## SERVICE BULLETIN

NUMBER 001

MODEL MX83

### SUN VISOR VANITY MIRROR WIRE ROUTING

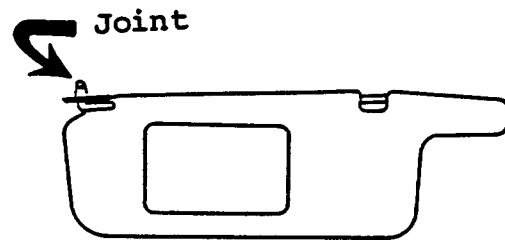
To improve the wire harness routing to the vanity mirror light, the design of the metal joint on the sun visor arm has been changed. The flare at the top of the metal joint of sun visor has been removed as shown below:
